Exhibit 916-1
Drainage Network Plan
Date: 1/1/2025

Exhibit 916-2
Drainage Network Profile
Date: 1/1/~~2025~~
2026

Exhibit 916-3
Drainage Network Cross Sections
Date: 1/1/2025 ~~2025~~ 2026

Exhibit 916-4
Optional Materials Tabulation
Date: 1/1/~~2025~~ 2026

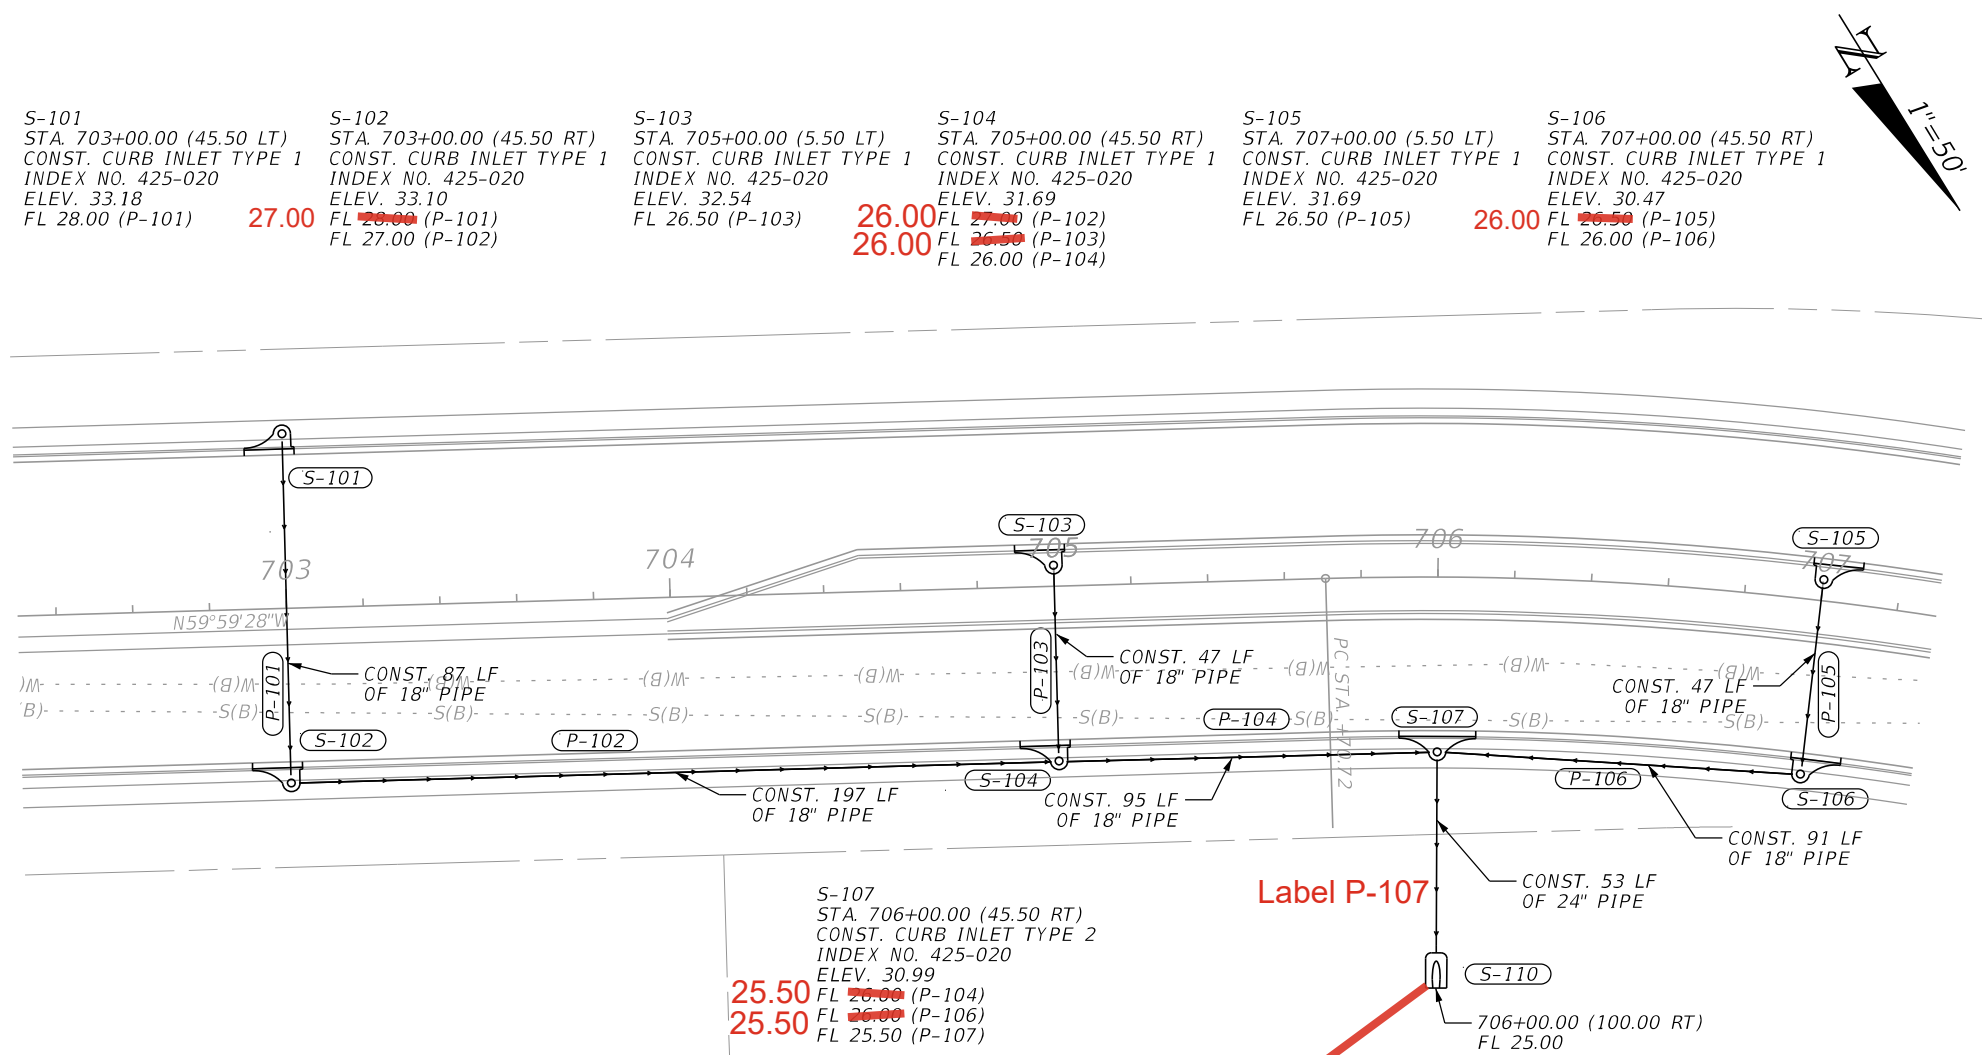
On this sheet - we say 18" PIPE,
But on the sections - we say 18 IN PIPE
Do we want to be consistent?

Also, do we need to call-out the structure bottoms as Type P?

Where do we call-out
the type of MES for S-110?

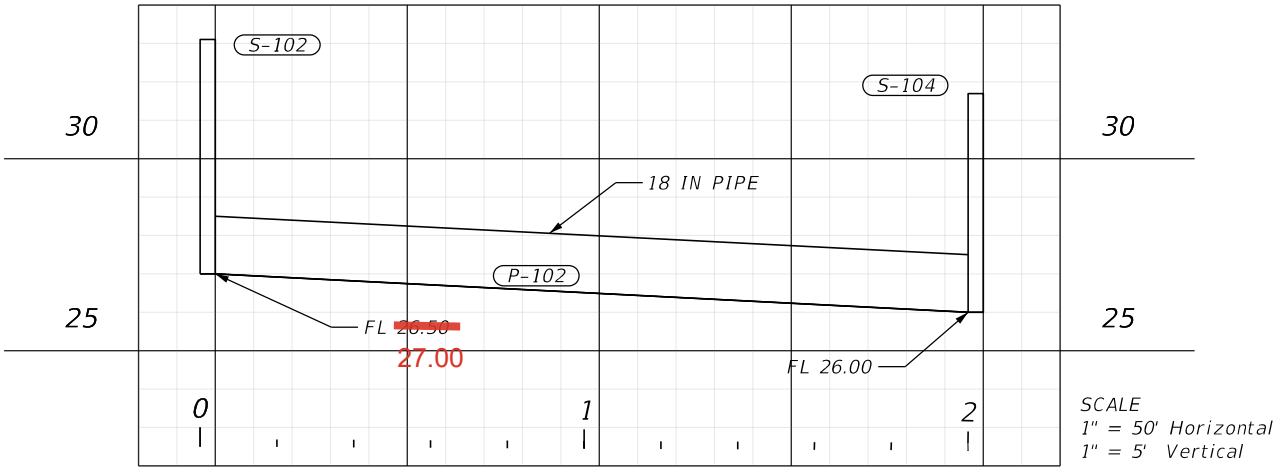
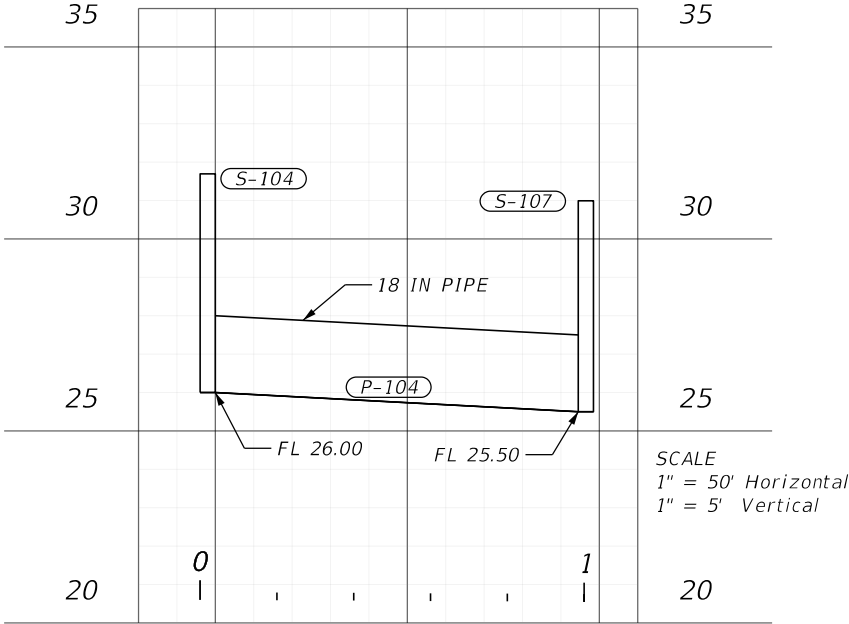
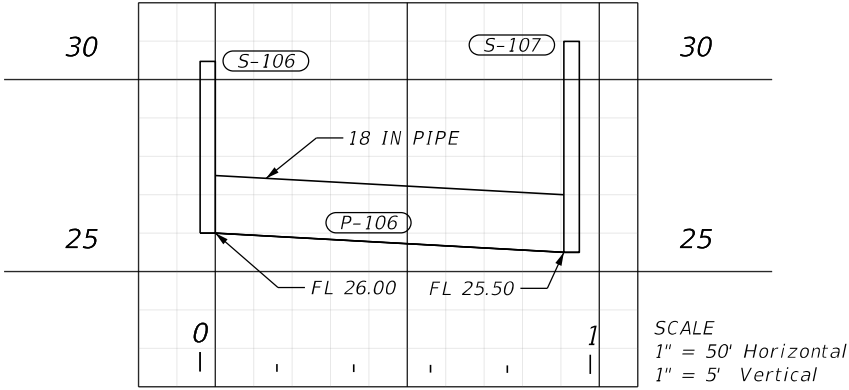
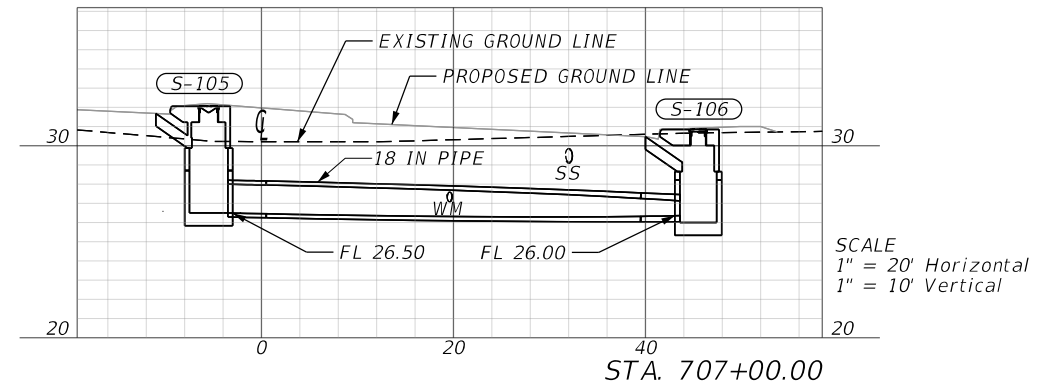
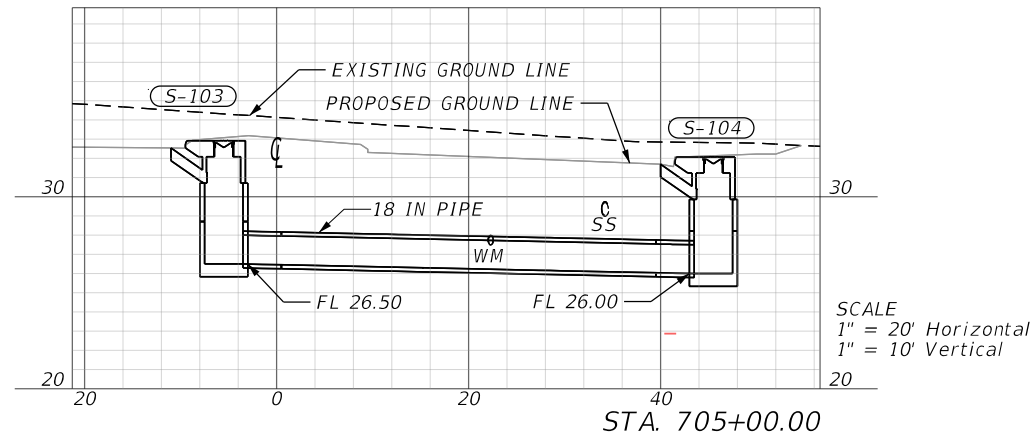
Should we label the pipe numbers on this sheet?
